Author response to reviewer comments

Anonymous Reviewer #1

Review of Williams et al., Small emission sources disproportionately account for a large majority of total methane emissions from the US oil and gas sector

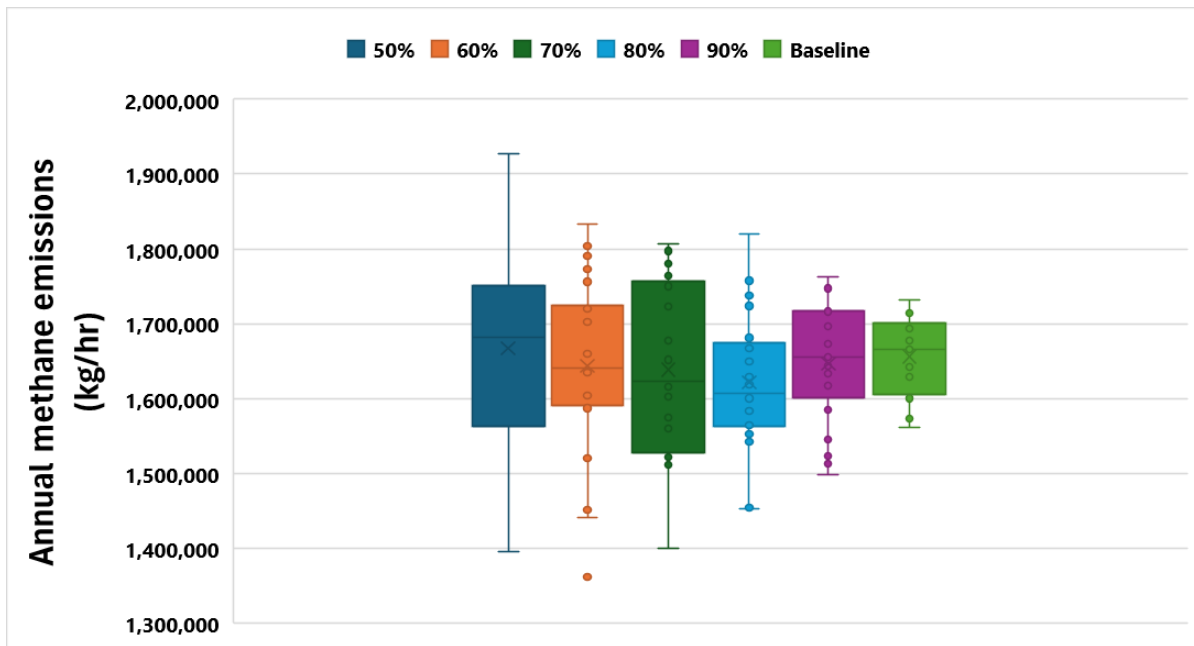
A MC bootstrapping technique may be more interesting if applied to randomly select which EF studies to include. For example, if 6 of the 11 studies of facility category “Well Sites” listed in Table S1 were randomly selected for each simulation, then we might assess dependence based on regional dependence of studies, sampling/analytical methodology, etc. Indeed, regional differences are maybe observed, e.g. loss rates of 0.90% for Appalachian and Greater Green River regions (Omara et al, 2018) compared to >4.5% for San Joaquin and San Juan regions, but the variance within the regional populations precludes saying these loss rates are different (based on a Tukey test). Could the Tukey test be run on the $\log_{10}(\text{loss } \%)$, given that these appear to be lognormally distributed in Figure 1?

We agree with the reviewer that this would be an interesting sensitivity analysis to perform, so we conducted two additional tests (shown in the responses below). The tests examine the impacts of 1) Reducing the number of empirical measurement data to be used in the estimates and 2) Eliminating data from a given oil/gas basin/region (well sites only given limited data on regions for midstream assets. In order, the sensitivity tests show 1) reducing the number of empirical measurements only increases uncertainty bounds but does not affect the overall emission distributions or total emissions estimates 2) excluding data from certain regions does not generally impact our results for emission distributions or total emissions, even for the Appalachian where the majority of our empirical measurement data are located, with the analysis performed on all 9 basins varying the emission distributions by +/-3-4% and our total estimates by +/-6-7%, which is well within our stated uncertainty bounds.

We have since removed the Tukey tests due to this new suggested sensitivity analysis related to the impacts of excluding empirical measurement data from given oil/gas basins. We believe this revised approach better characterizes the uncertainties related to the spatial distribution of measurement data we use in our estimates, since it also includes additional factors such as the relative counts of facilities, differences in oil/gas production, and the number of empirical data available from each region.

- The Tukey test figures have been replaced with a new Figure S9 displaying the resulting changes in total methane emission distribution curves (A) and total methane emissions for the CONUS (B):

- Below is a figure illustrating the effects of reducing the sample size of empirical measurement data on total methane emission estimates for the CONUS. 25 iterations are performed for each barplot. “Baseline” refers to the full suite of empirical measurements as we use in our manuscript. Note that we see increased variation in results from a 50% reduction of measurement data relative to our baseline, with no significant change in the average total methane emissions

- Below is a figure illustrating the effects of reducing the sample size of empirical measurement data on methane emission distributions for the CONUS. 25 iterations are performed for each emission distributions. “Baseline” refers to the full suite of empirical measurements as we use in our manuscript. Note that we see increased variation in results from a 50% reduction of measurement data relative to our baseline, with no significant change in the overall emission distributions

- Comparison of total CONUS oil/gas methane emissions when including/excluding ERG 2011 empirical data for 25 estimates each.

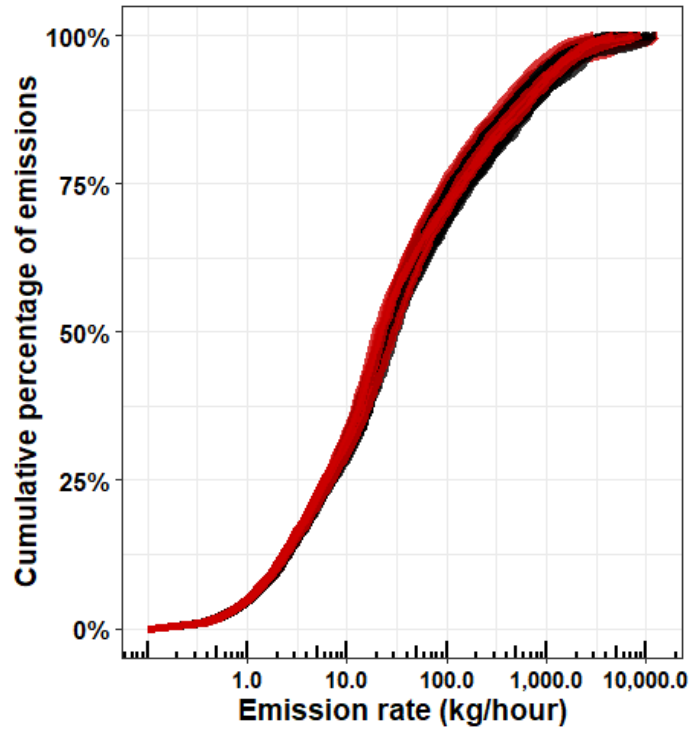
There are several other references used by Omara 2018 not included in this study. (Goetz et al 2015, ERG 2018).

With regards to Goetz et al. 2015, we have since included these data into our dataset of empirical measurement data. The addition of these data (n=3) do not change our results and main findings in any significant way.

We only know of the ERG 2011 study, but we would be happy to investigate a more recent component-level study if another exists. For the ERG 2011 dataset, we decided to exclude it given that it is an older dataset (10+ years) and a compilation of component-level measurements, which we acknowledge in our work may underestimate total facility-level emissions given that there is no guarantee that all emitting components were measured. While we do include some component-level aggregation studies in our work, both of those studies (Riddick et al. 2019, Deighton et al. 2020) provide measurements within the past 10 years. However, we did perform a sensitivity analysis on the effects of including versus excluding the ERG 2011 data and found no change in our model results for both total emissions and the emissions distributions (see below).

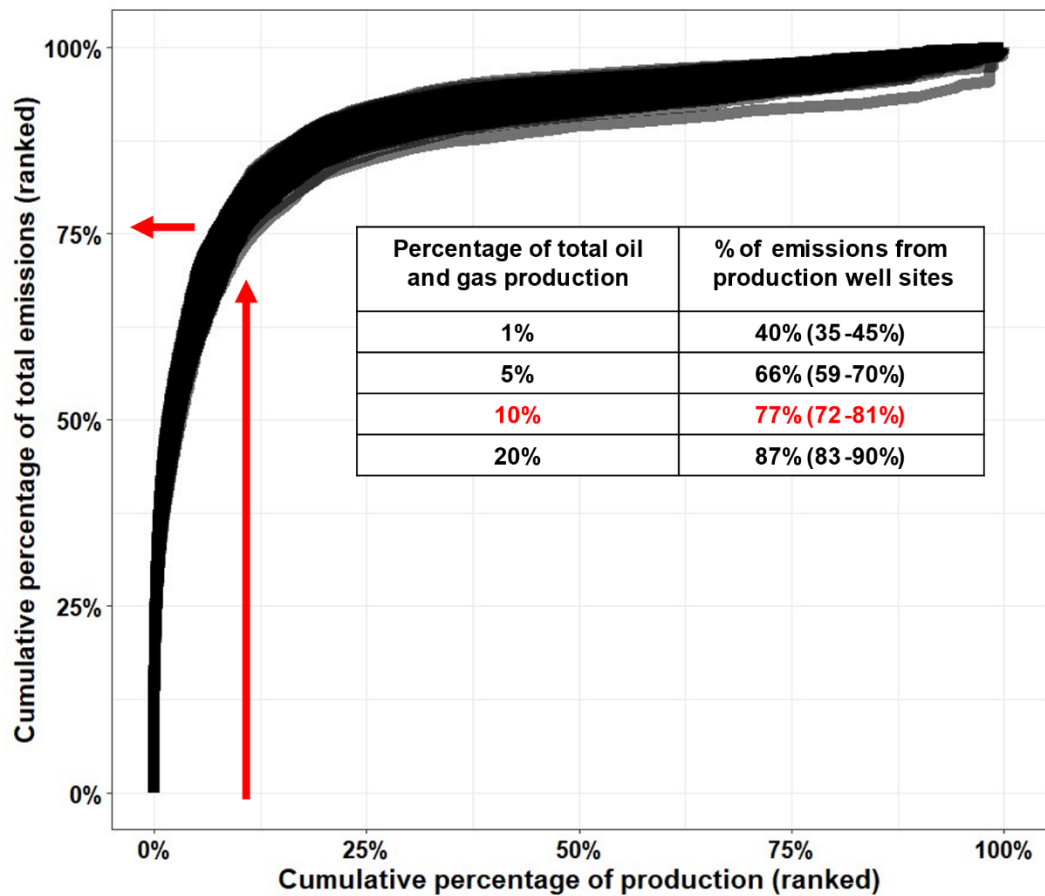
My biggest concern is that this (and the title of the manuscript) imply a discrepancy between previous and new analyses, which is in fact not the case, and this is not well communicated. I strongly encourage the authors to clarify the change in perspective/framing and where it originates from. It is very clear from Fig 6 of the manuscript that in the category Well sites (<15 boed) there are almost no super emitters according to the absolute definition (>100 kg/h), so it is no surprise that they don't contribute much to emissions. And since this category contributes most to the annual emissions, (Fig 6b) the category strongly lowers the weight on super emitters to the national totals. This should be explained more clearly!

We note the reviewer's concerns on the perspective/framing of the paper and we agree that this is an important point to highlight and explain. Overall, the narrative surrounding oil/gas methane emissions has largely focused on the relationship between facility counts and total emissions, in the sense that a small percentage of the highest emitting facilities (i.e., super-emitters) contribute a disproportionate fraction of total emissions (which we also observe in this work). While these are important findings, our focus is on the relationship of emission rates to cumulative emissions, which we believe to be more critical information relating to methane measurement methodologies, especially with the rise of aerial remote sensing platforms with higher limits of detection. Furthermore, we present these results in the context of total national US oil/gas methane emissions, accounting for important information such as facility counts and facility types. As the reviewer correctly states, low-producing well sites are the major source of

emission in our work, and individually do not emit at high rates, but cumulatively contribute a majority of total oil/gas methane emissions. Low-producing well sites also exhibit the same relationship of facility counts to cumulative emissions, since a small number of the highest emitting low-producing wells contribute the majority of their cumulative emissions. However, these “super-emitting” low producing well sites emit at roughly ~10 kg/hr, which is well below the detection thresholds of satellite point-source imagers, and also some aerial remote sensing platforms.

To better clarify the change in perspective/framing, and to better highlight the contribution of low-producing well sites, we have made the following changes to the main text.

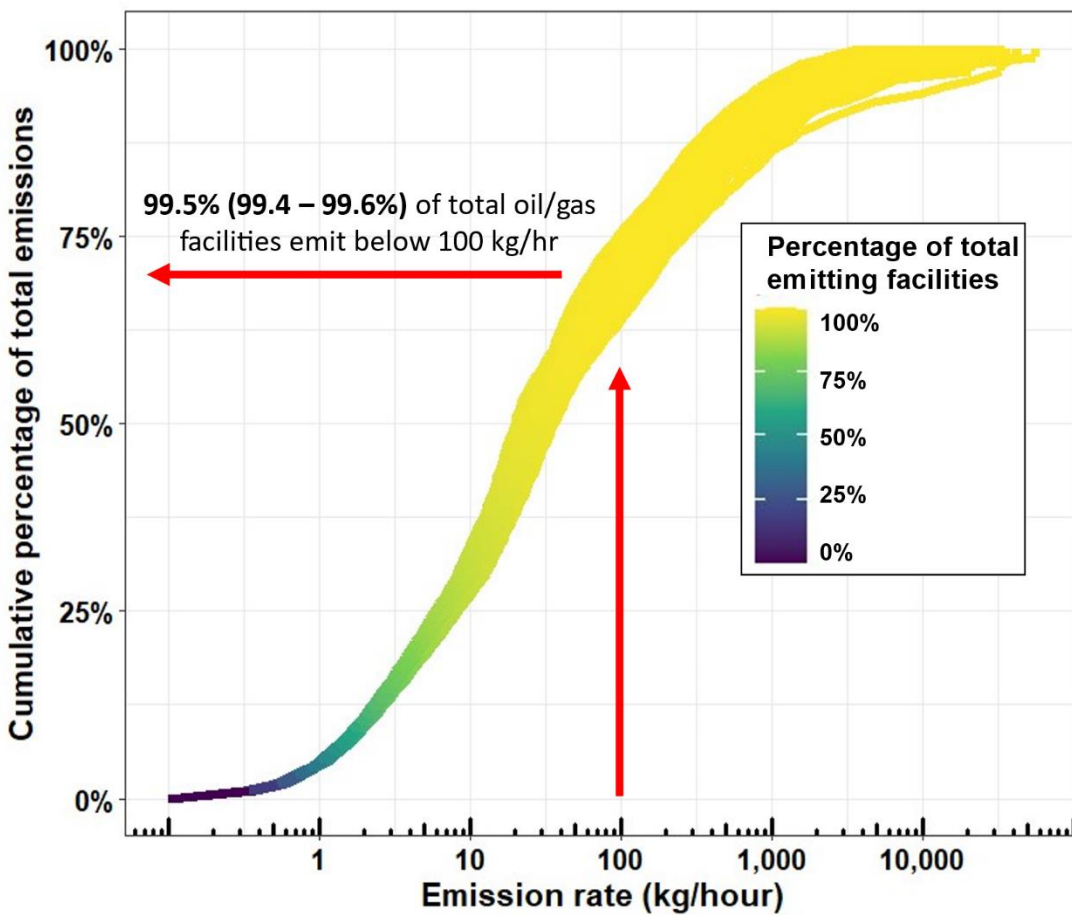
I find Fig. 2 complicated and it could be simplified in 2 aspects:

- 1) remove the “loop over i” going back to the start, and simply state that you do this for all facilities, (then also remove the index i).
- 2) show separate paths for categories 2, 1&3, and 4-9. I understand that this can be incorporated in an algorithm but this “high level” and rather trivial criterion makes the flow confusing.

These suggestions are very helpful, and we have since incorporated some of these changes into Figure 2 as suggested by the reviewer, including our revised approach for unlit and lit flares. The revised figure 2 was previously shown in a prior response to the reviewer.
